**ADDENDUM NO. 01 – PORTAGE PUBLIC SCHOOLS – HAVERHILL ELEMENTARY SCHOOL BP 5:  
FOOTINGS AND FOUNDATIONS**

## ADDENDUM NO. 1 [BP 5]

<b>DATE OF ISSUANCE:</b>	June 15, 2023
<b>PROJECT:</b>	<b>Haverhill Elementary School Bid Package 5: Footings and Foundations</b> 6633 Haverhill Avenue Portage, MI 49024
<b>OWNER:</b>	Portage Public Schools
<b>ARCHITECT'S PROJECT NO.:</b>	21-237.25
<b>ORIGINAL BID ISSUE DATE:</b>	May 25, 2023

**1** GATHERING STAIR PARTIAL PLAN  
 1/4" = 1'-0"

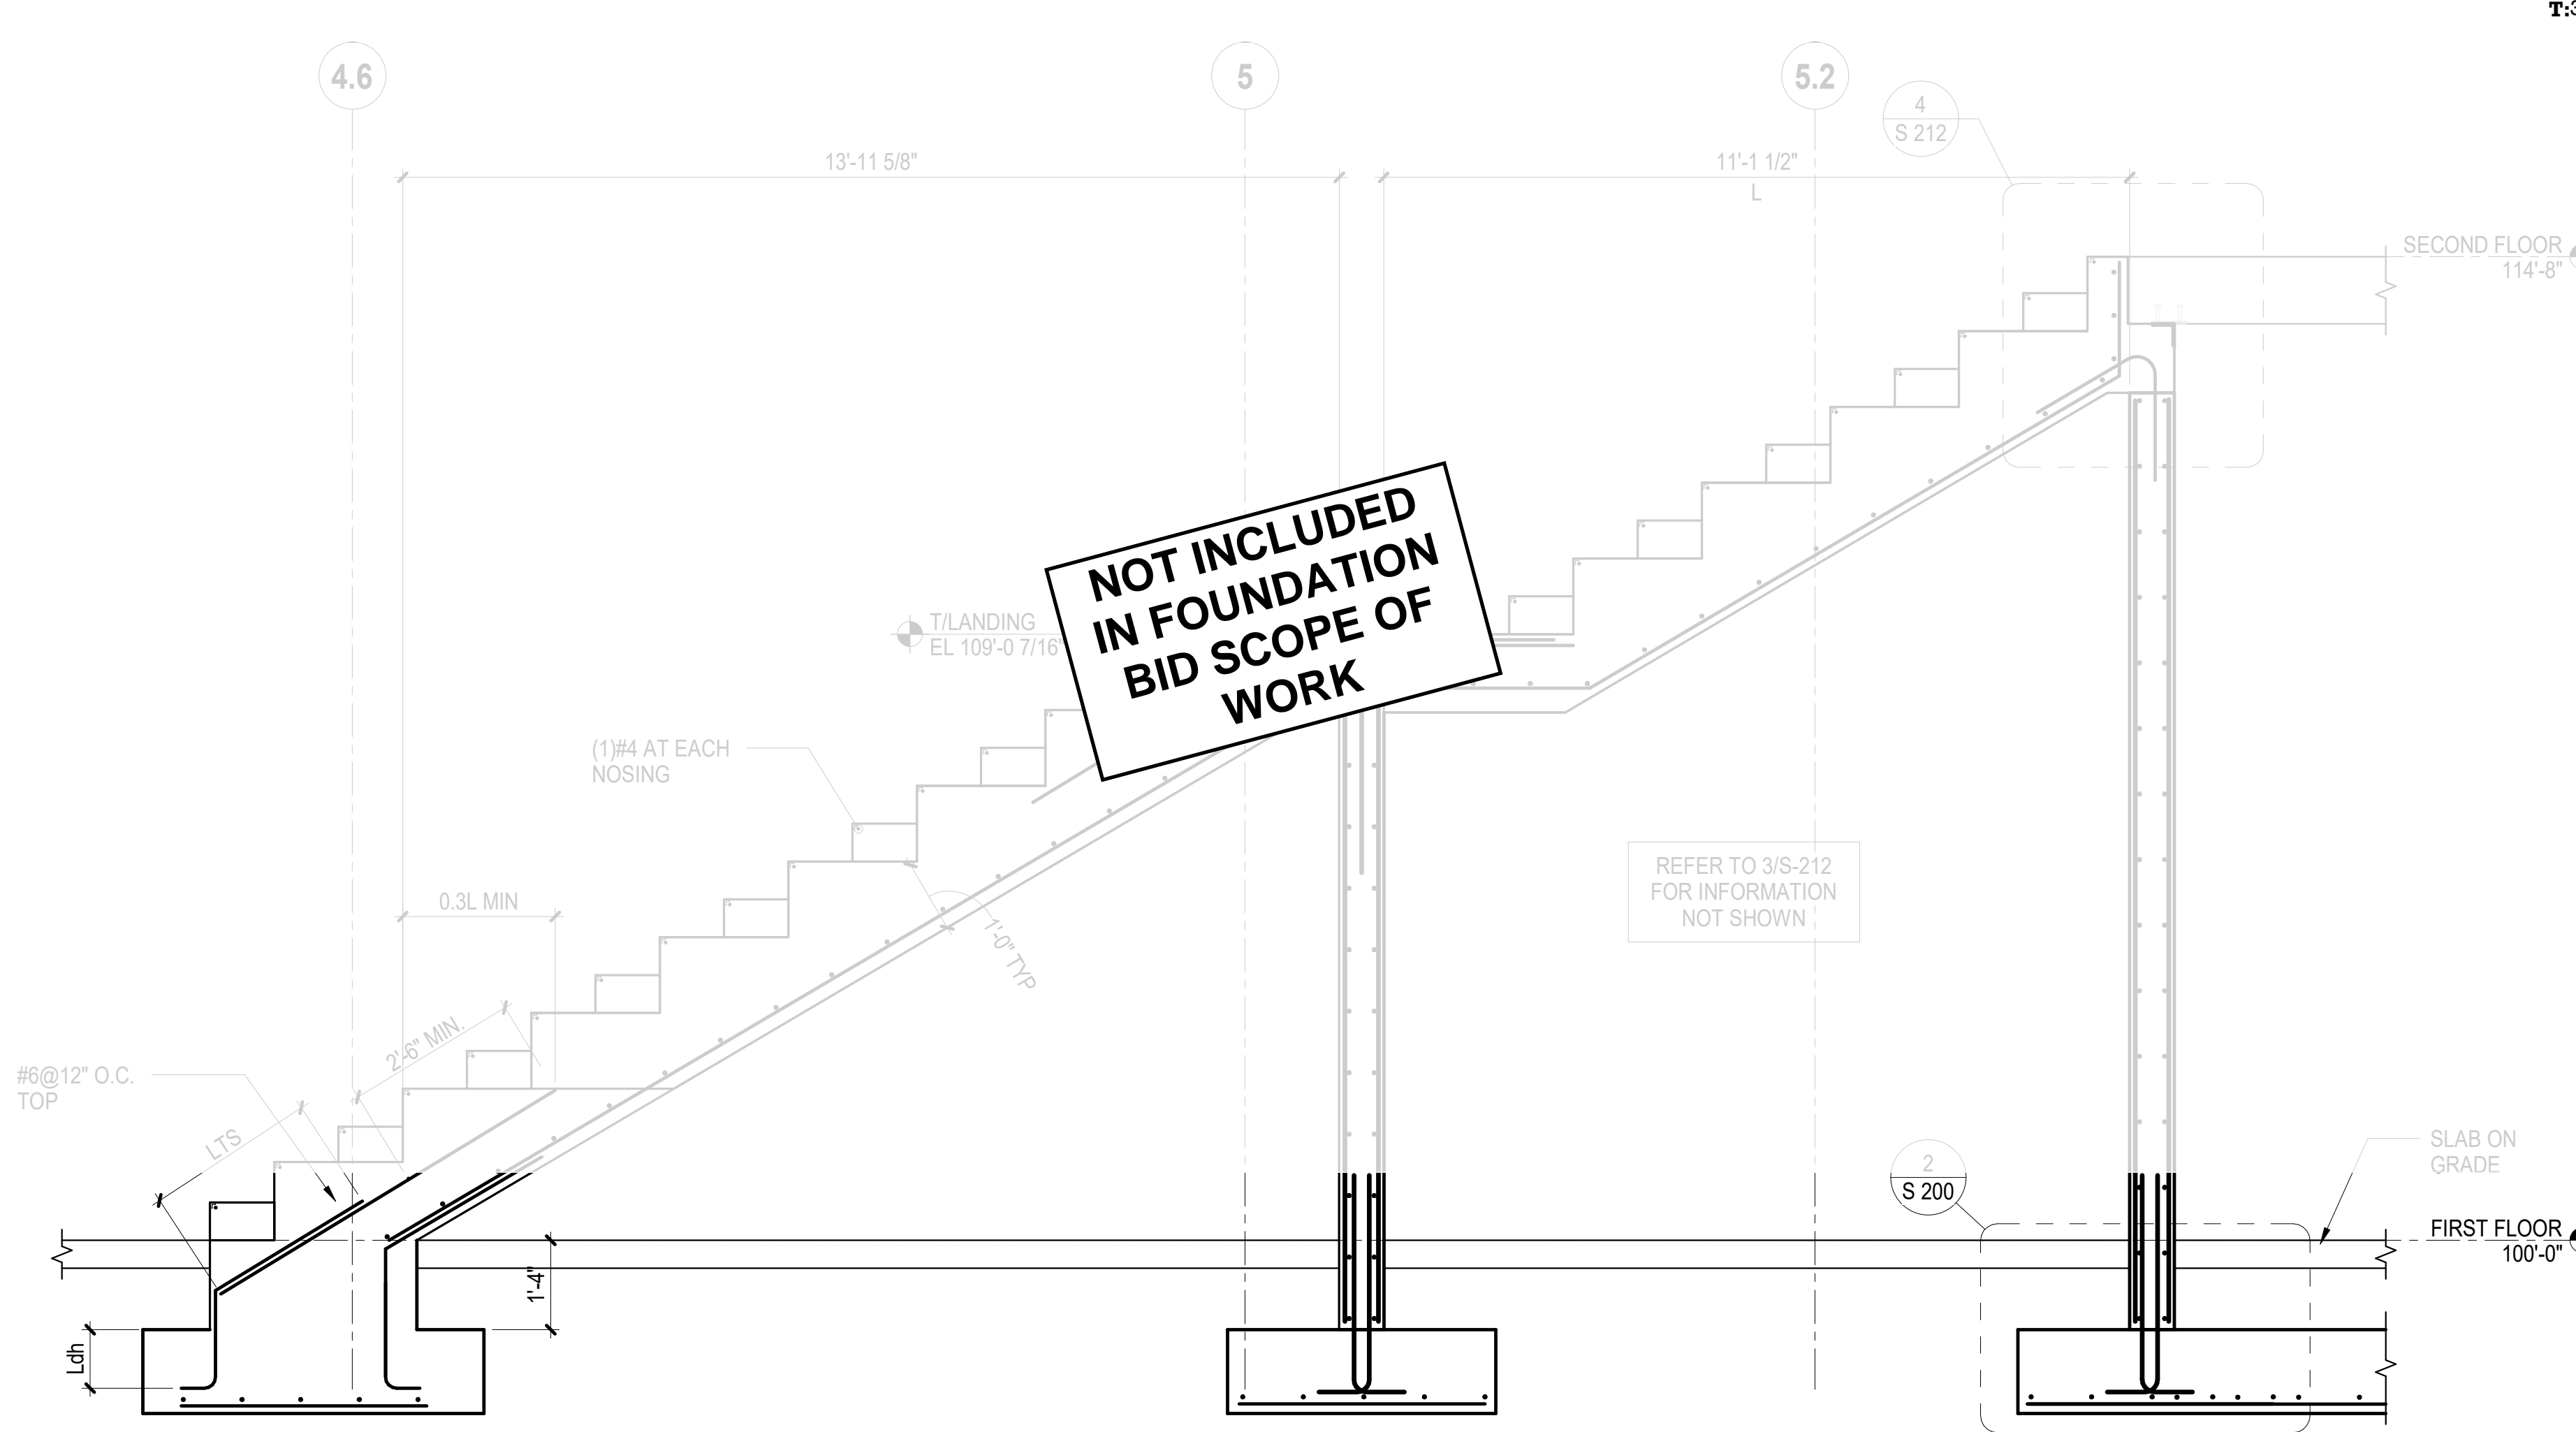
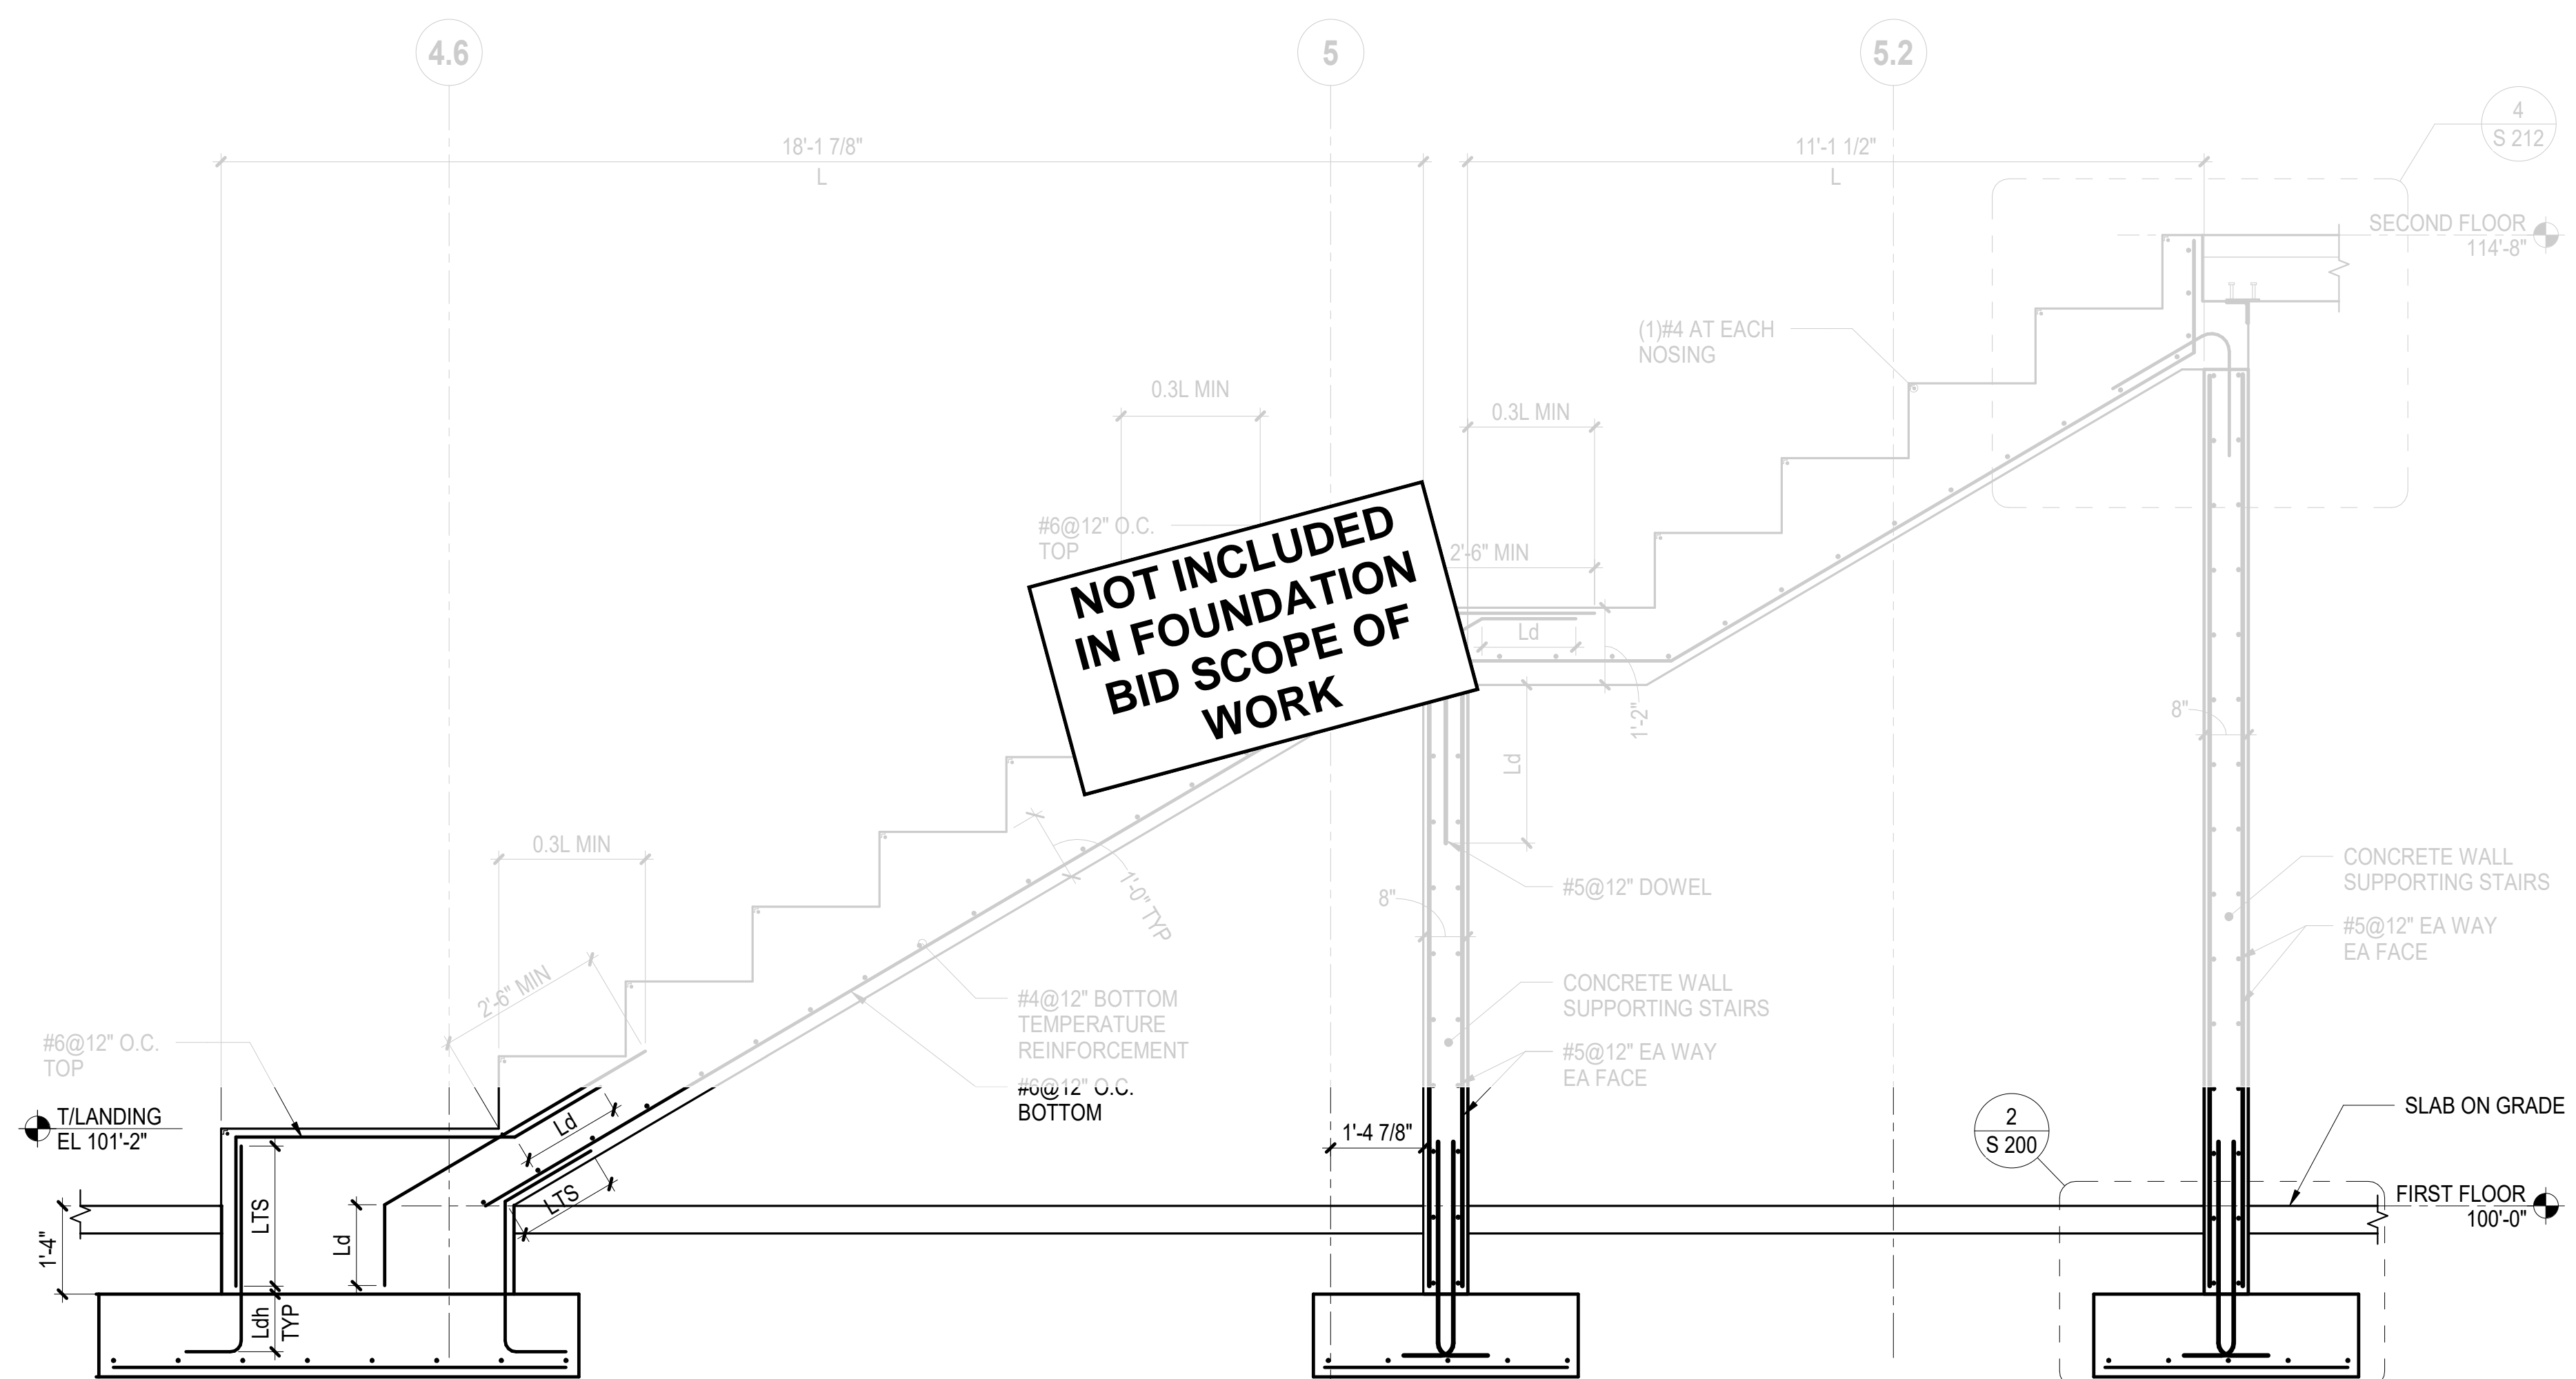
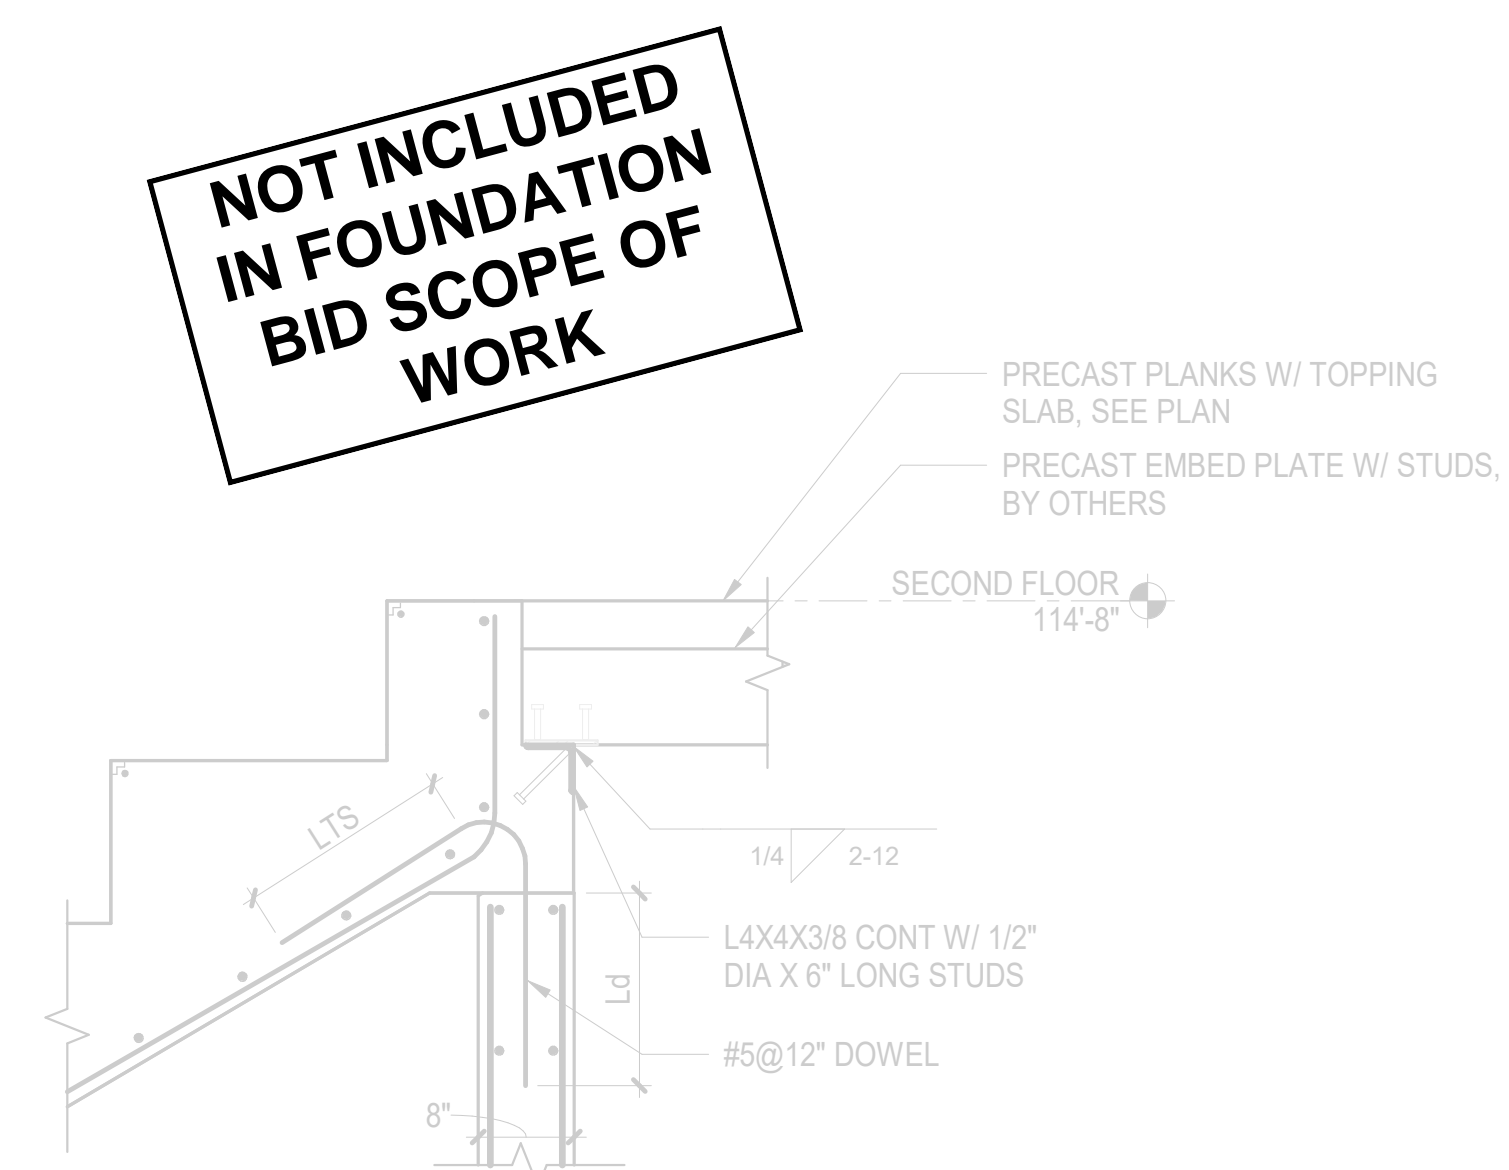
Refer to Sheet(s): S212

- updated footing geometry at gathering stair footings
- Shifted gathering stairs to match arch
